TRANS/WP.29/GRSG/2002/
2002

Working Party on General Safety Provisions (GRSG)
(Eighty-second session, 29 April - 3 May 2002,
agenda item 2.)

PROPOSAL FOR A REVISION TO REGULATION No. 52
(small M2 and M3 passenger vehicles)

Transmitted by the Expert from the United Kingdom

Figure 21

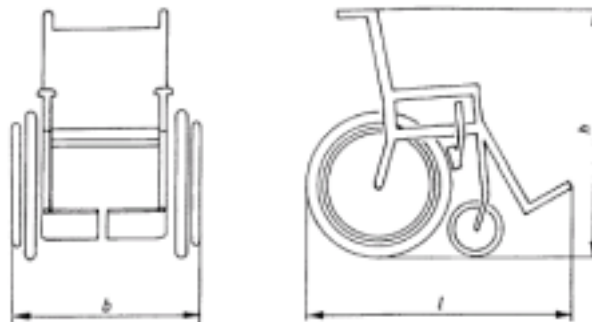
Annex 3, Add:

Overall length, l: 120 cm
 Overall width, b: 70 cm
 Overall height, h: 109 cm

A wheelchair user seated in the wheelchair adds 5 cm to the overall length and makes a height of 135 cm above the ground.

- 3.6.4 It shall be possible to move from the outside of the vehicle through at least one of the doors for wheelchair access into the special area(s) with a reference wheelchair of the dimensions shown in Annex 3, figure 21.

Figure 22

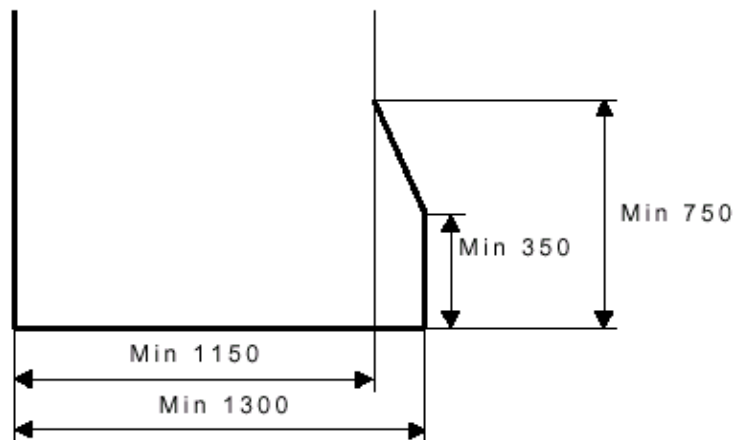
Minimum clear space for the wheelchair user at the wheelchair space

(Note: Diagram as shown above but with units in cm)

- In the case of a wheelchair space designed for a forward facing wheelchair, the top of preceding seat-backs may intrude into the wheelchair space if a clear space is provided as shown in Annex 3, figure 22.
